**Energy Strategy:
Response to Element
Energy**

Berkeley Homes (Oxford & Chiltern)
Ltd.

Vastern Road

Final V3

Figure 2 – Total Annual Costs

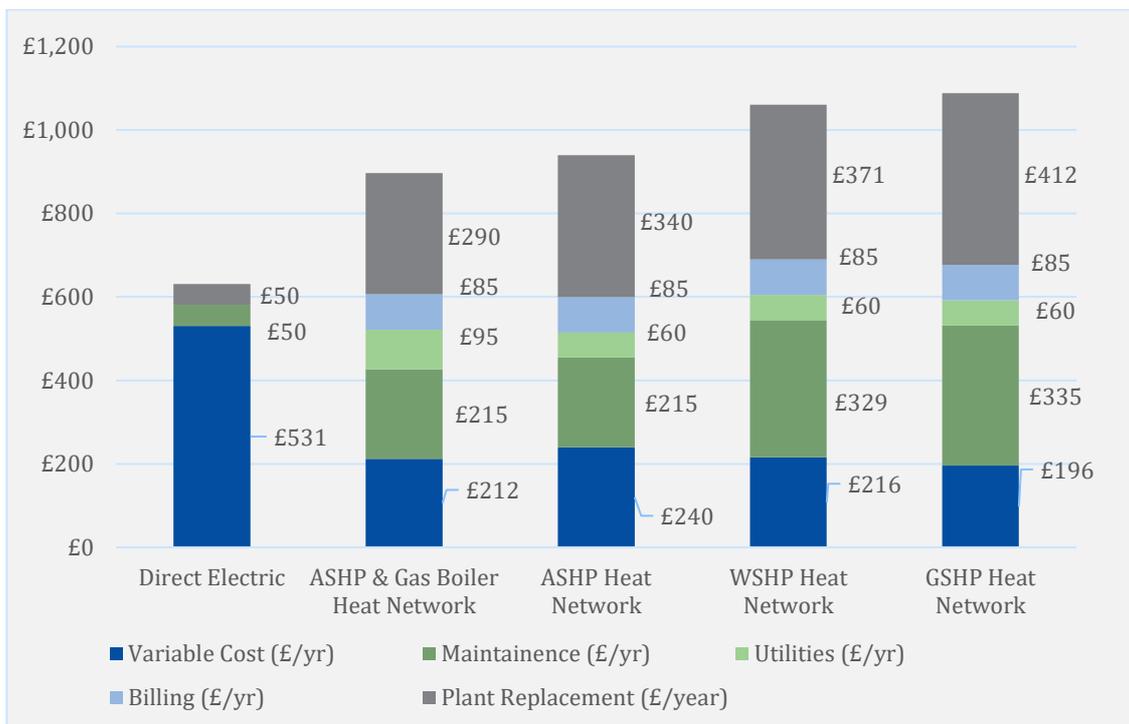
- 2.8 It is shown that although heat consumption costs (variable) are lower for all heat network scenarios, the much higher fixed costs mean that overall residents are expected to be paying at least 40% more in heating costs than the proposed direct electric system. An open-loop GSHP could result in costs which are as much as 70% higher.
- 2.9 This analysis has been repeated for instances where the dwelling heating demands may be 50% higher or 50% lower than anticipated through SAP calculations, or where heat network losses would be much lower. These results are shown in Appendix B, and demonstrate that under each of these conditions direct electric heating still represents the most cost-effective system for residents.
- 2.10 No Renewable Heat Incentive payments have been assumed due to the risk that any plant will not be commissioned before March 2022.

Figure 3: Borehole Data (<http://mapapps.bgs.ac.uk/geologyofbritain/home.html>)

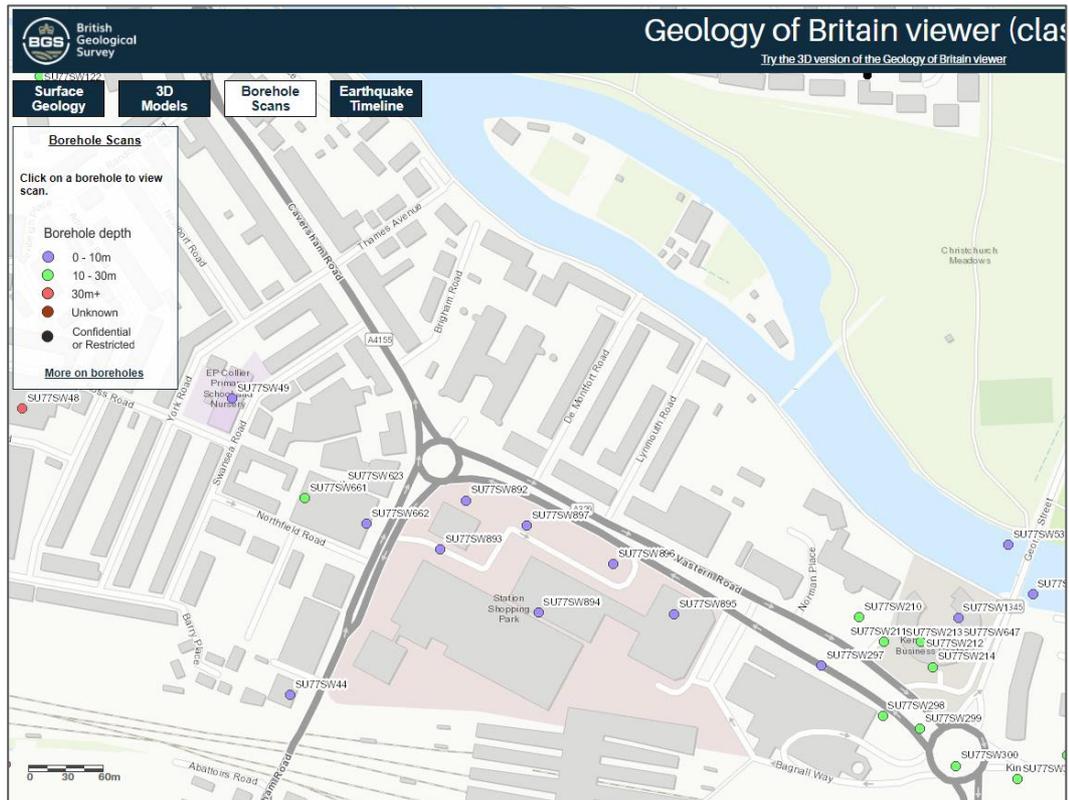
- 3.16** There are no existing borehole records within the vicinity of the site at a depth of more than 30m available from the British Geological Survey website (Figure 3, below).

drawing number **O.448.SK.001** revision /

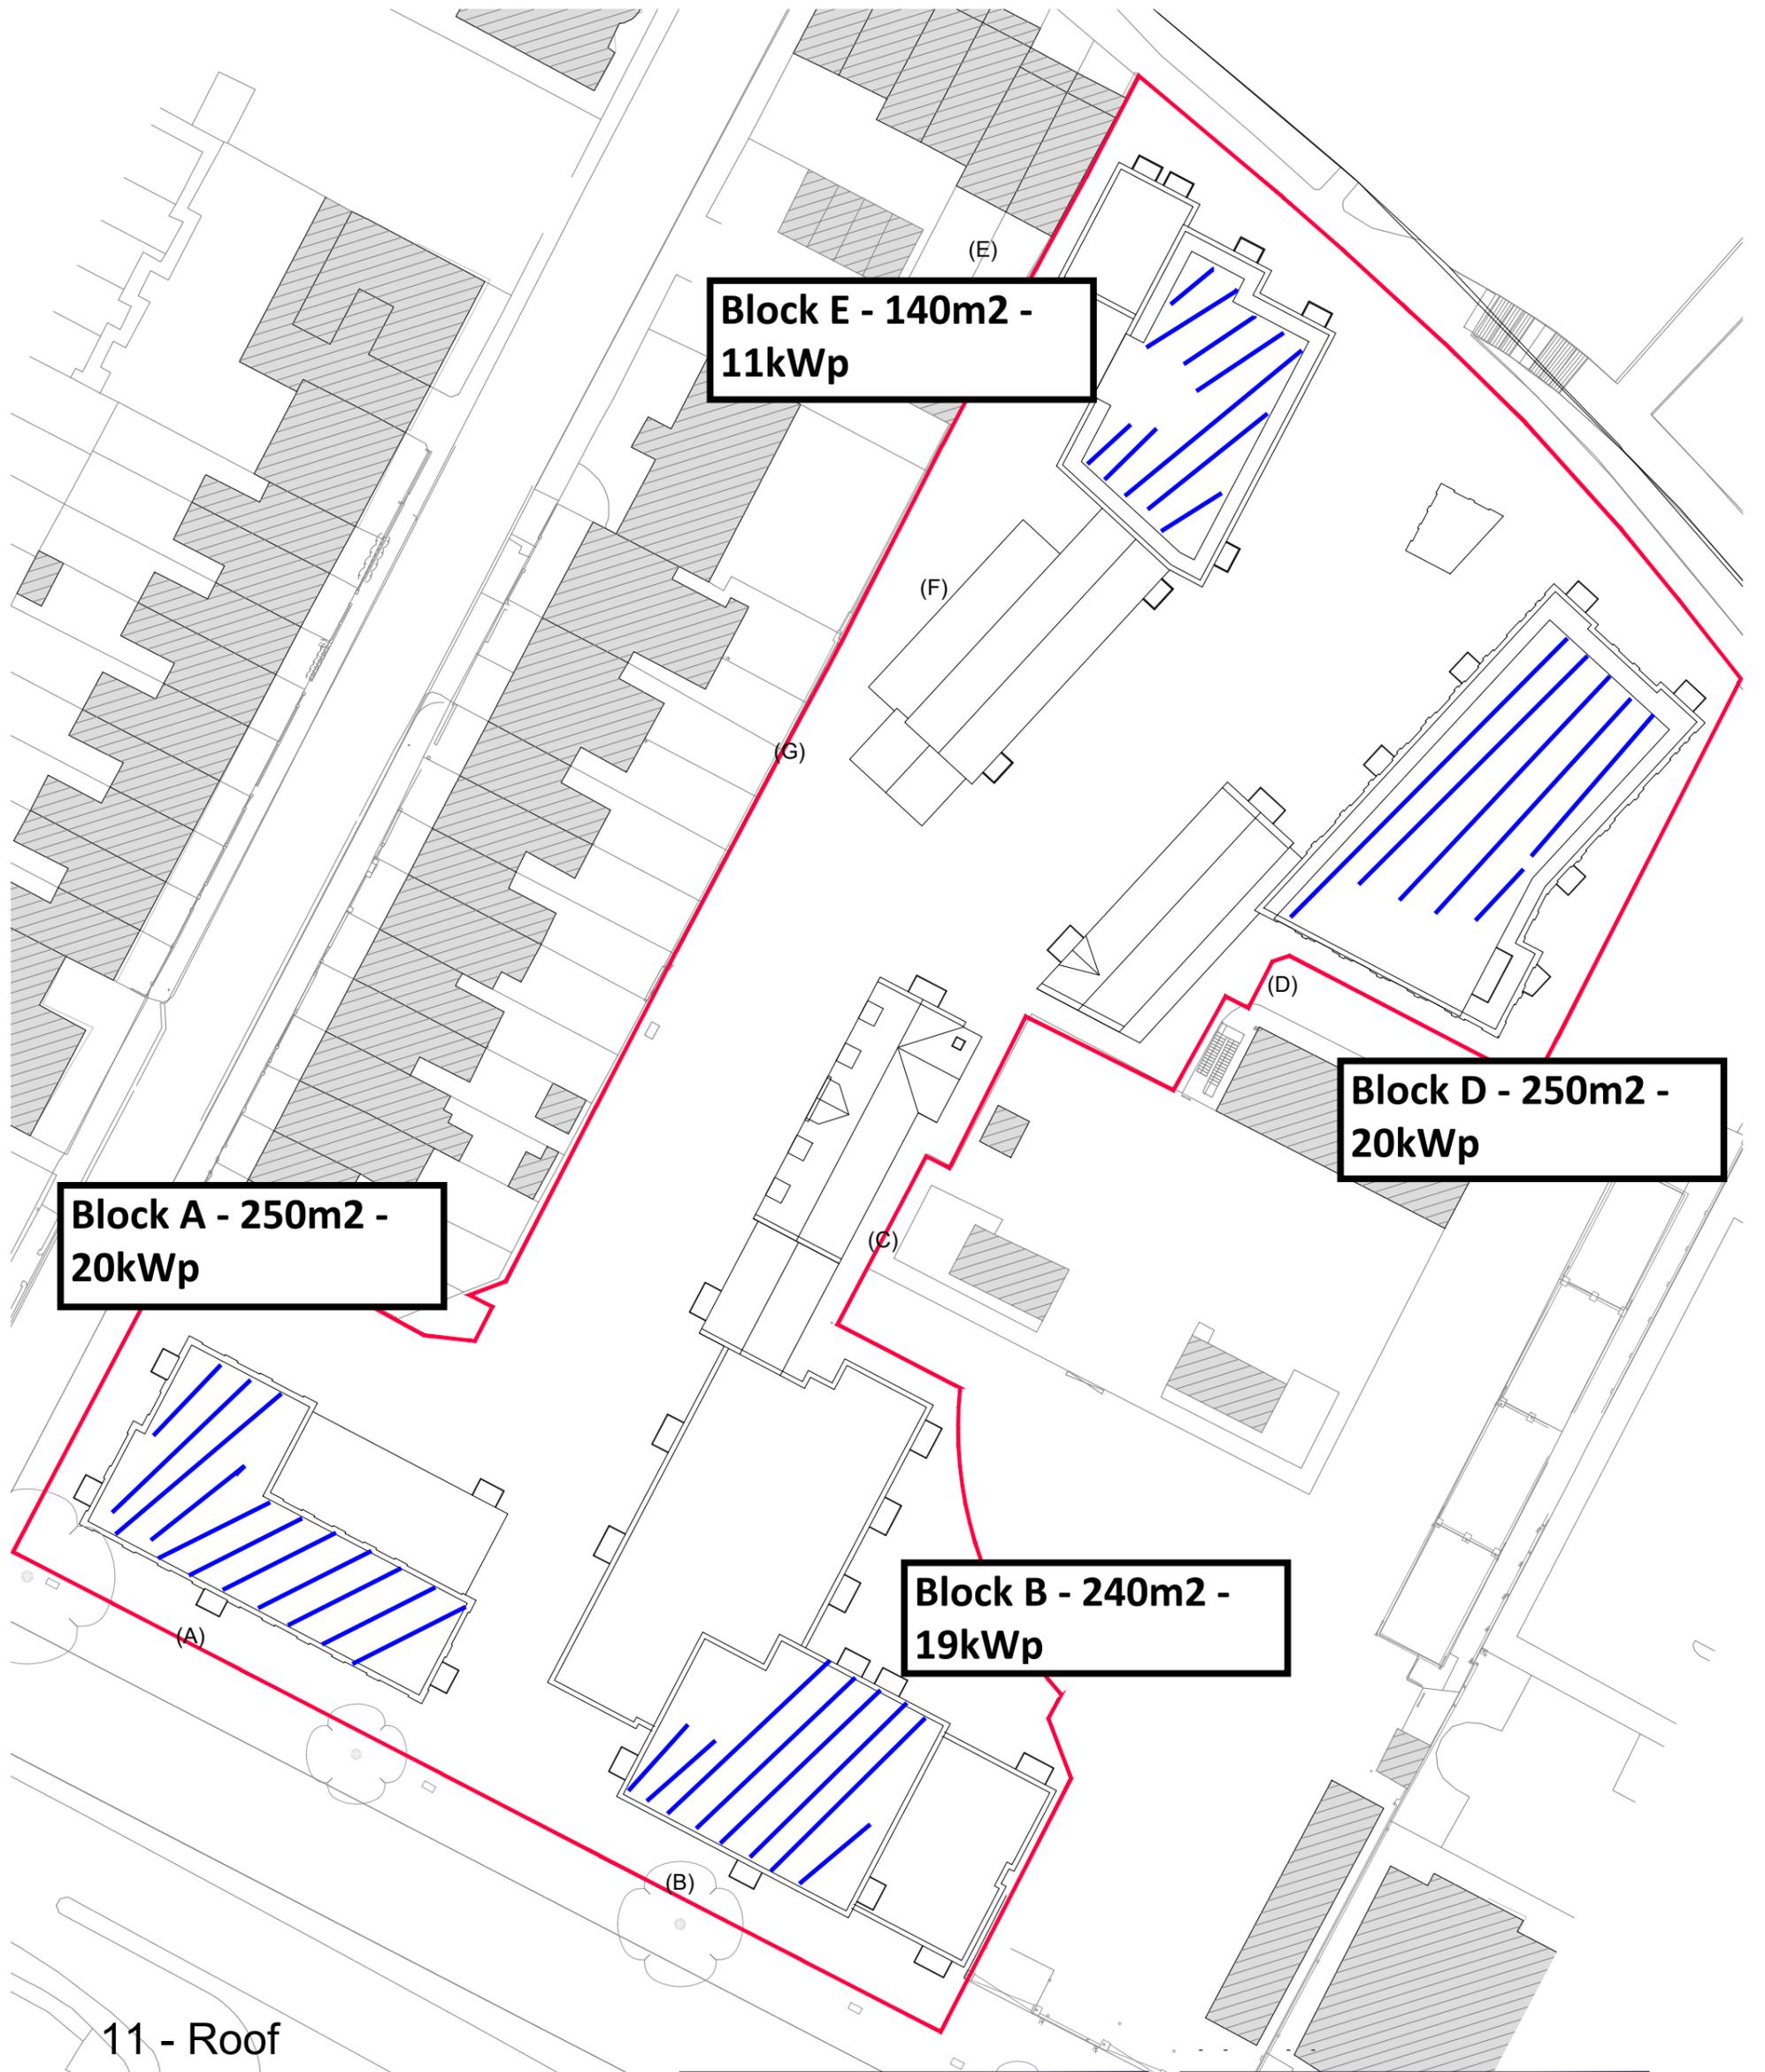
- 3.11 The high number of boreholes, trenching and overall space required for a closed loop GSHP system mean that this solution is not a possibility for a dense site such as Vastern Road. The total site area which has been deemed appropriate for the installation and ongoing access of boreholes is 1,939m². This is significantly lower than the lowest spatial requirements estimated by both Element Energy and Hodkinson Consultancy, and an 8m spacing between boreholes could not be achieved. A site plan showing the available area has been included in Appendix C.
- 3.12 The ground on and around the development also has a contamination risk, due to the site previously hosting a power station. This presents a further complication.
